**DEVIATION REQUEST** (Attach diagrams, figures, and other documentation to clarify request)

A deviation from the standards of or in Section **2.3 Roadway Design** of the Engineering Criteria Manual (ECM) is requested.

Section 2.3 Roadway Design, Detail SD\_2-11

A modified typical section illustration is provided below:

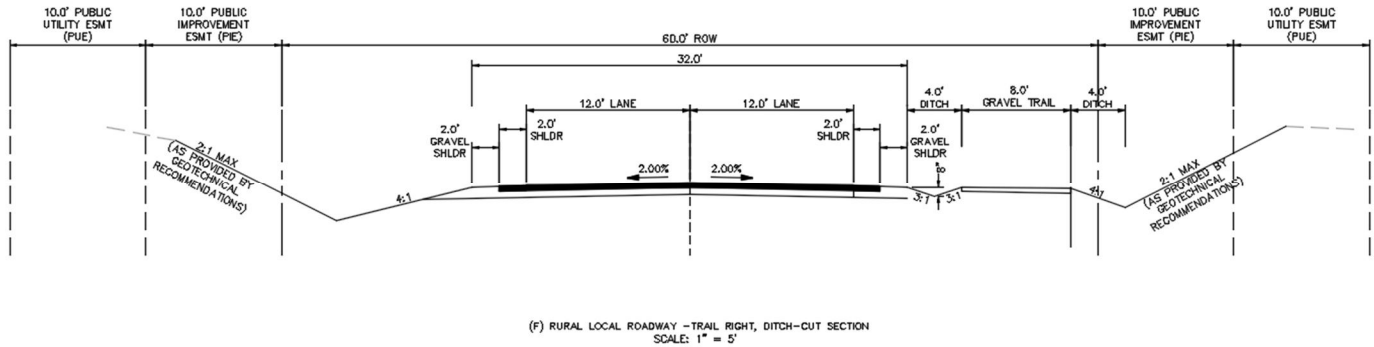
identify if this is  
outside the clear  
zone.
